Wizards Workshop

January 30, 1981
Issue 11-2

EXTENSION SHAFTS (W-KNOBS)

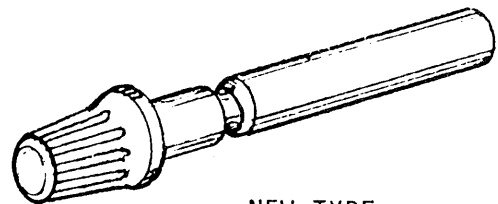
If you have instruments with knobs and shafts molded together, with binding problems here is good news.

The shafts have been slightly modified, to correct the binding problem, and are a direct replacement of the old type. Also, the cost is reduced by half.

Parts redesigned and dash numbers changed:

384-1371-00----becomes 384-1371-05

384-1371-01----becomes 384-1371-06

384-1371-02----becomes 384-1371-07

384-1371-03----becomes 384-1371-08

EDGE VIEW OF 670-6330-04
AFTER INSTALLATION
OF TERMINAL.

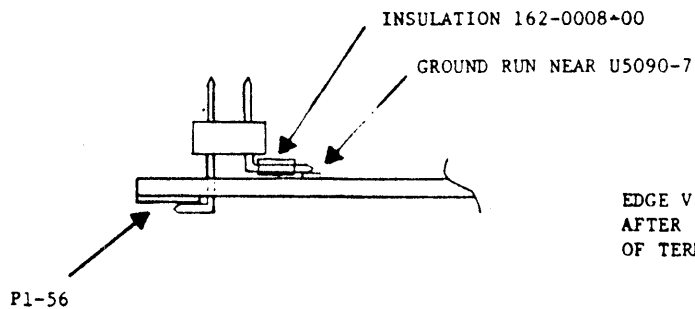
670-6330-XX - Emulator modification is required as follows:

1. Remove a small area of solder mask on the ground run at U5060 Pin 10 on the front side of the board.
2. Install a 1.0 inch piece of AWG 20 stranded wire between U5060 Pin 10 and edge connector P1 Pin 15. Mask off gold contact to prevent wicking. Note AWG 20 is not standard mod wire.

3. Remove a small area of solder mask on the ground run at U5110 Pin 10 on the front side of board.
4. Install a 0.5-inch piece of AWG 20 stranded wire between U5110 Pin 10 to edge connector P1 Pin 85. Mask off gold contact to prevent wicking.

5. On front side of board remove a small area of solder mask from ground run on U5090 Pin 7. Directly under mask removal, drill a hole large enough for a .025 inch square pin to go through easily. Locate hole between, but just above, edge connector P1 Pins 55 and 57.

7. Insert the other unbent pin through the drilled hole. Add insulation to bent pin and solder to ground on U5090 Pin 7.
8. On back of board, bend unbent pin over to edge connector P1 Pin 56, cut to length and solder. Mask off gold contact to prevent wicking.

9. On back side of board install a 1.75 inch piece of 20 AWG stranded wire between U5070 Pin 10 and Edge Connector P1 Pin 16.
10. For 8550 operation install jumper (P/N 131-0993-00) between terminal pins just installed, remove jumper for 8001/8002A operation.
